## **Main Library**

## Library- Main

## Accessibility Review

**Photo 2:** Modify policy to allow independent use of the elevator. Currently staff assistance is necessary to reach ground floor (Michigan St).

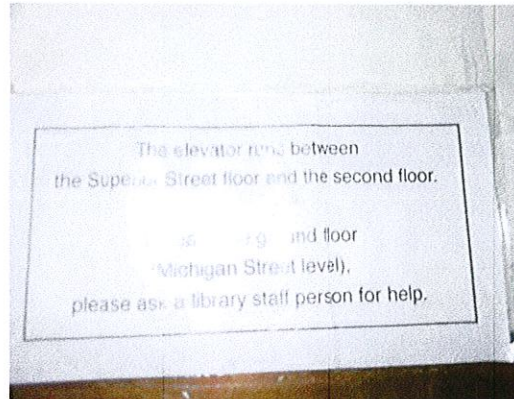
Location JQP # / Item #	Solution / Comments	Qty	Unit Cost	Total Cost	Priority	Estimated Compl. Date	Person Responsible	Actual Compl. Date	Actual Cost
<b>Elevator</b>									
18N 15699	Modify/replace elevator to allow unassisted entry, operation and exit. MN1341 407.1 <i>Currently staff assistance is required to take the elevator to ground level (Michigan Street) due to security concerns. (There are public spaces located on all levels.) Photo 2.</i>	1	\$100,000	\$100,000	1				
<b>Staff Toilet Room- 2nd Floor</b>									
22D 15720	Remove interior partitions to create a single use toilet room. It is recommended that a privacy lock be installed. ICC / ANSI 603.2 <i>JQP, Inc. recommends converting this location to a public single-user accessible toilet room. Currently no other toilet room in the building provides a toilet with 60" clearance. This location is recommended because: it is not within a secure staff area, it is not designated as 'children only' and there is only 1 fixture.</i>	1	\$1,500	\$1,500	1

**Photo 4:** Relocate a typewriter to an accessible location if requested. (The current private cubicles are too small.)

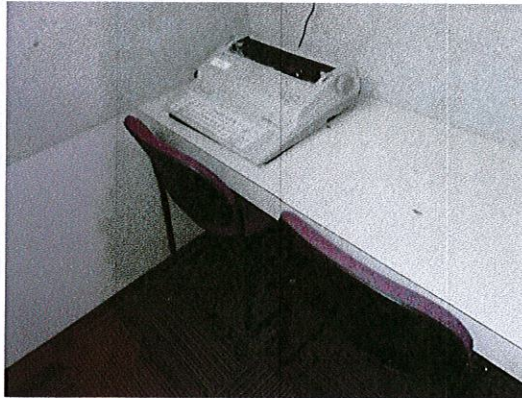
<b>Typewriter Rooms- 2nd Floor</b>									
14D2 15718	Relocate program as necessary to an accessible location to provide program access. MN 1341 1104.4 <i>The private typewrite rooms currently have a 30" clear door and the space is 54" wide overall. Relocate 1 of the typewriters to an accessible location as needed. Photo 4.</i>	1	\$0	\$0	1				
				<b>Priority # 1 Total</b>	<b>\$101,500</b>
